ADDENDUM NO. 1 - OUTLINE AND SUMMARY INFORMATION

Project Name: Leon Johnson Redundant Heat Pump Module

PPA No.: 19-0042

Date: November 3, 2021

1 BASEMENT MECHANICAL PLAN
M100
1/4"=1'-0"
NORTH REF

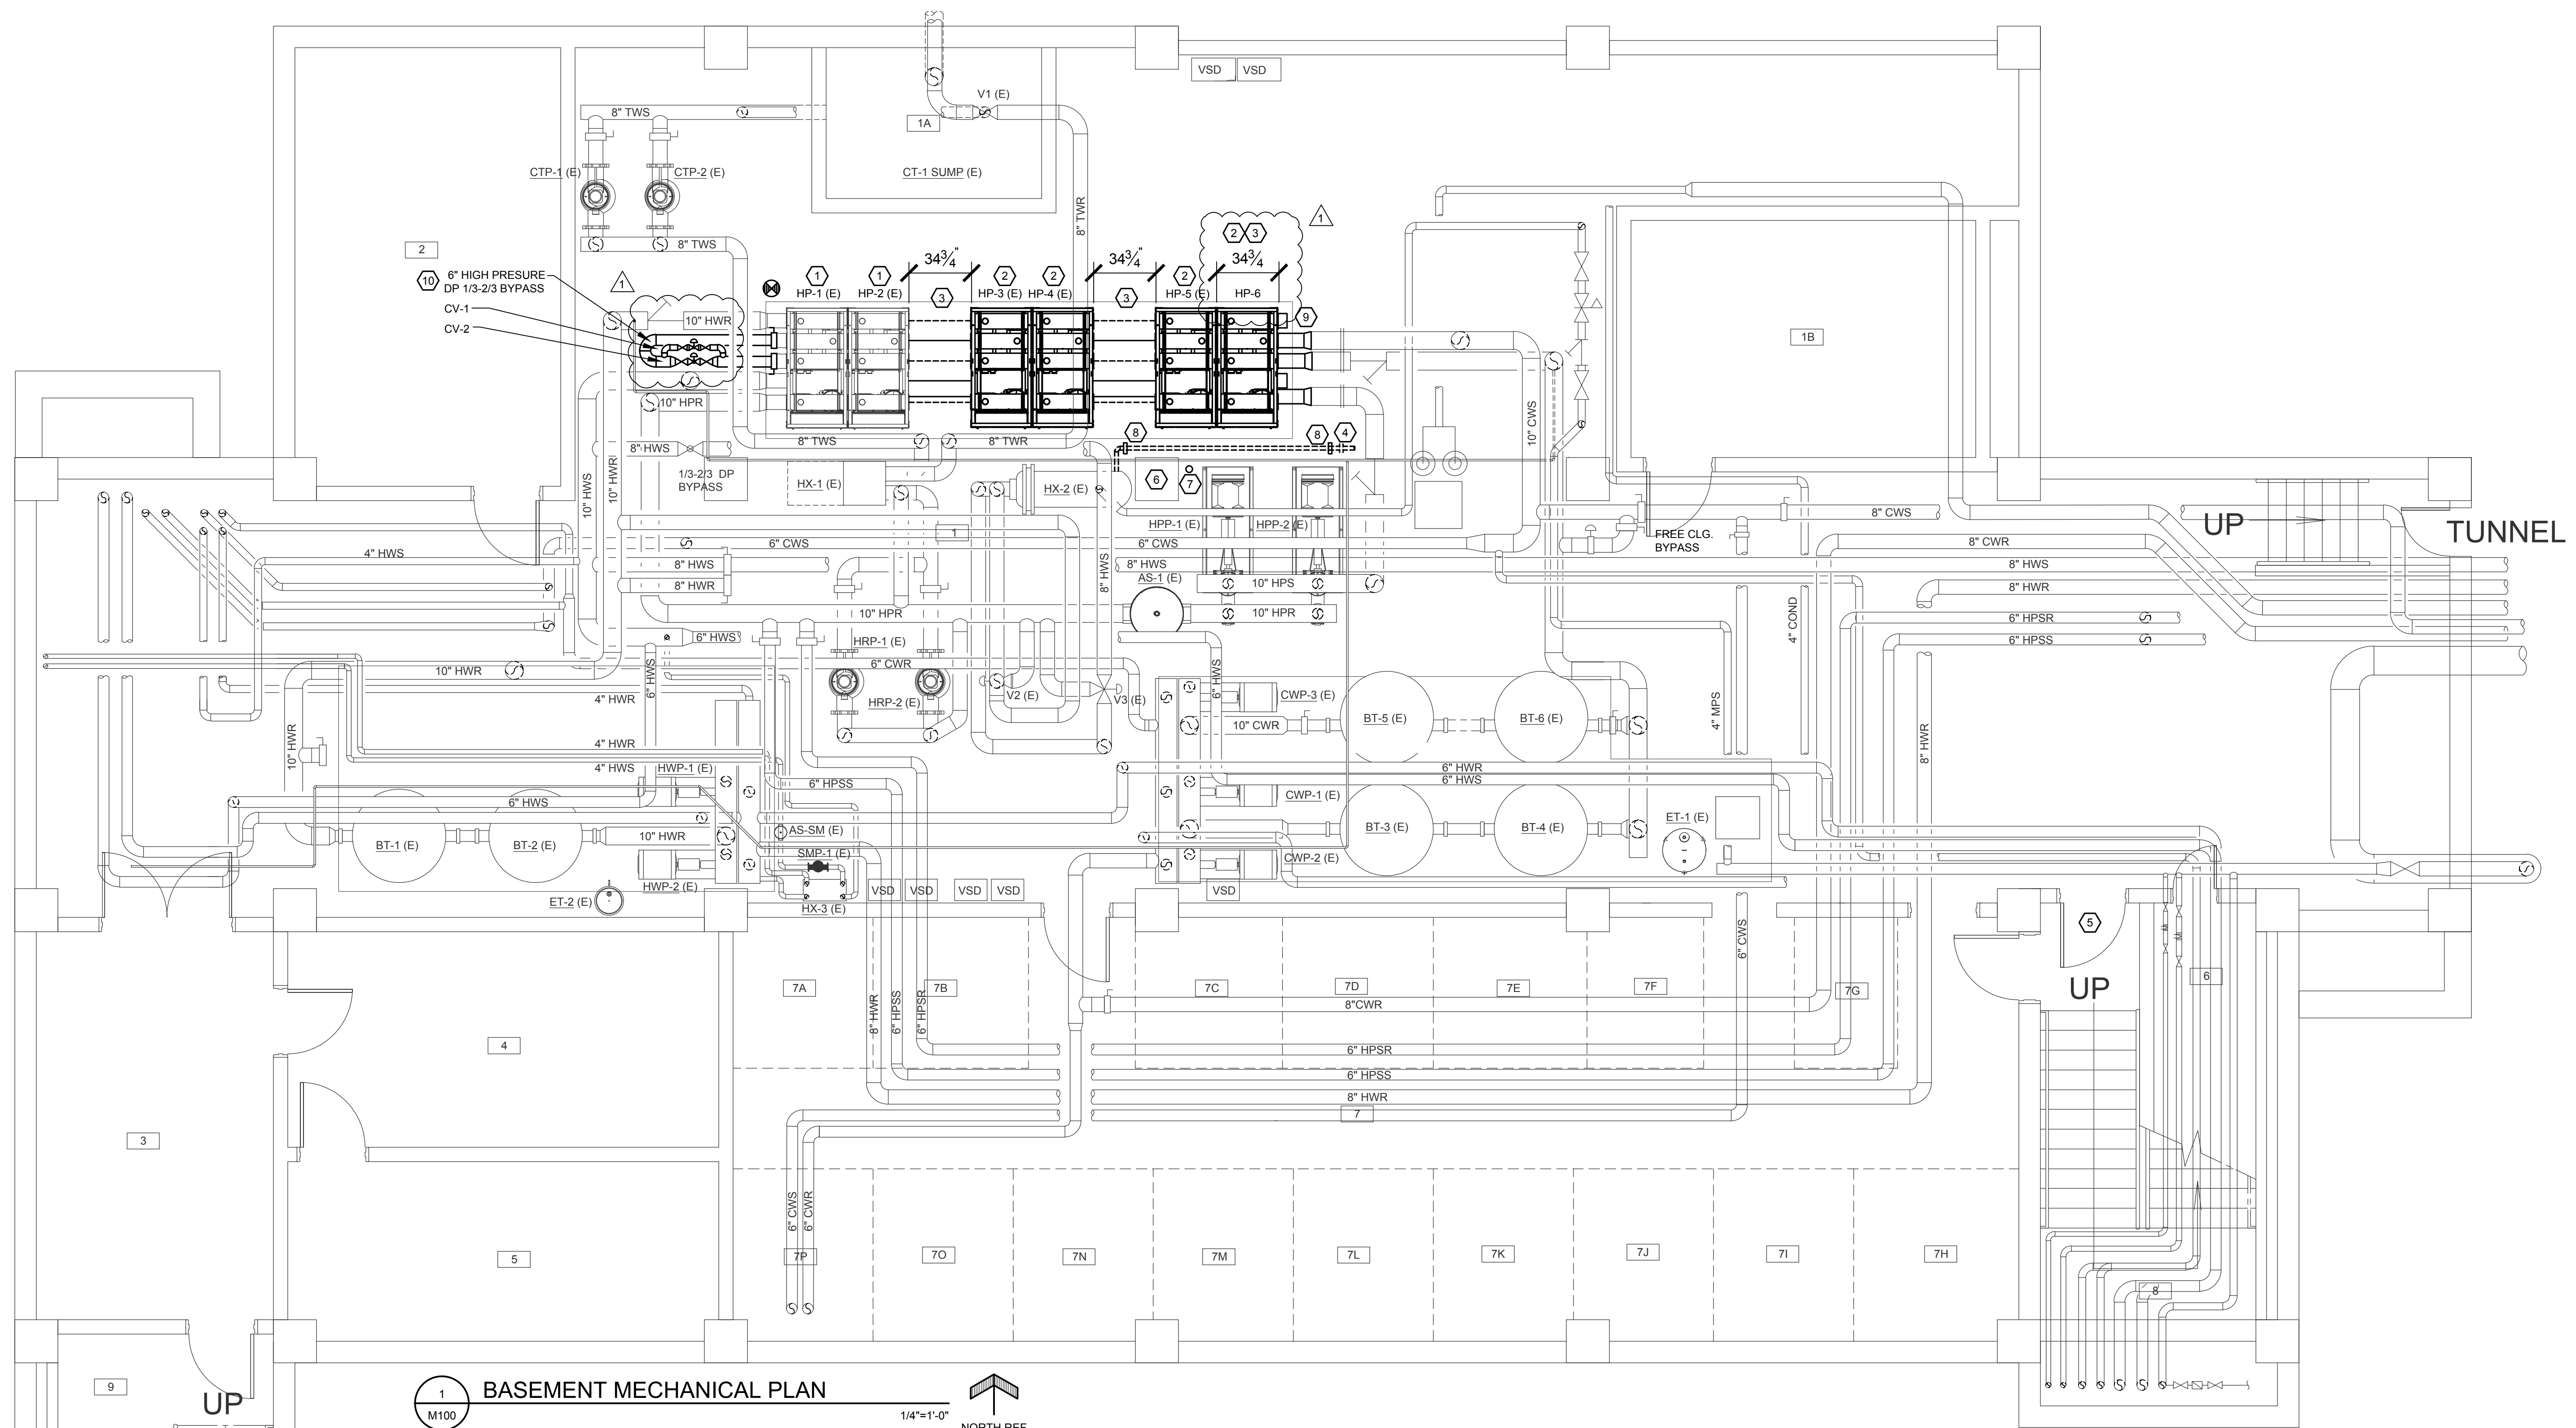
- SHEET NOTES**
- 1 HP-1,2 TO REMAIN IN PLACE.
 - 2 NEW PLACEMENT OF HP-3,4,5 AND ADDITION OF HP-6. PROVIDE TEMPORARY SPOOL PIECES AS NOTED ON G100.
 - 3 PROVIDE SPOOL PIECES TO ALLOW FUTURE UNITS TO BE ADDED WITHOUT MOVEMENT OF EXISTING UNITS. FIELD VERIFY HEAT PUMP SPOOL PIECE LENGTHS AND CONNECTION CONFIGURATION WITH MANUFACTURER.

- 4 FLANGES TO BE ADDED FOR REMOVAL OF 2" CONDENSATE PIPE FOR MAINTENANCE.
 - 5 PROPOSED BEST PATH FOR RIGGING HP-6 TO THE MECHANICAL ROOM.
 - 6 REMOVE EXISTING WALL HANGER FOR 2" CONDENSATE PIPE. MAINTAIN CLEARANCE FROM EXISTING COLUMN TO RELOCATED HP-5.

- 7 EXISTING 3" WASTE RISER TO REMAIN.
 - 8 PROVIDE FLOOR PIPE SUPPORTS FOR EXISTING 2" CONDENSATE PIPE.
 - 9 REMOVE, RELOCATE AND RECONNECT EXISTING VALVING, STAINERS, PIPE FITTINGS AND CONTROLS AS REQUIRED FOR THE INSTALLATION OF HP-6.

- 10 PROVIDE 6" HIGH PRESSURE 1/3 - 2/3 DP BYPASS AT THE ENDS OF THE CHILLED WATER SUPPLY AND RETURN HEADER.
